From: Plater, Roger - Oxfordshire County Council <Roger.Plater@Oxfordshire.gov.uk>
Sent: 06 January 2023 15:32
To: Simon Tucker
Cc: White, Joy - Oxfordshire County Council; Andy Bateson
Subject: 22-01488-OUT OS Parcel 5616 adj Huscote Farm and M40 J11

This email is a follow-up to the Transport comments contained within the second OCC response dated 30 November 2022 and to confirm the issues identified by our Traffic Signals officers in relation to the LinSig analysis, as discussed earlier.

Extracts from Proposed Network Layout Diagram showing three lanes from A361 to roundabout, and associated layout drawing

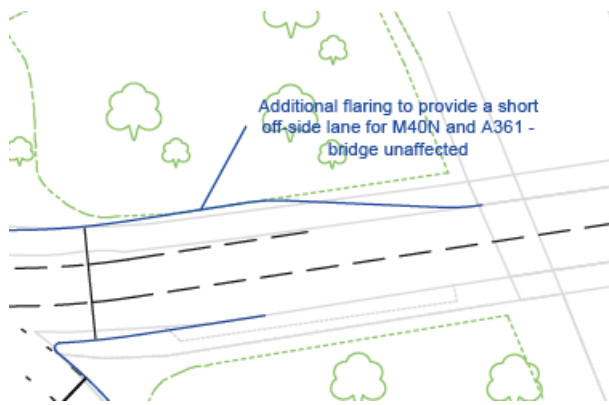
1. The layout drawing no. 23459-06-02-GA Rev. A, titled "M40 Junction 11 Gyratory" and contained in the TA Addendum, shows two lanes at the stop line where the A361 meets the roundabout. However, the LinSig model is not consistent with this as it includes a third lane for straight on and left turn to the A422. This third lane has a capacity of 10 PCUs; approximately equating to 57.5m in length. Inclusion of a third lane would be within the site boundary but will have a further implication to the embankment supporting the carriageway and potentially to the drainage as there is a pond nearby. Details of the extended embankment, including cross-sections, are required as the embankment will have to be adopted.

DTA will review and modify the layout drawing as necessary so that it is entirely consistent with the proposals analysed using LinSig. It is also recognised that the proposed layout changes will need to be incorporated into the VISSIM analysis model when that work progresses.
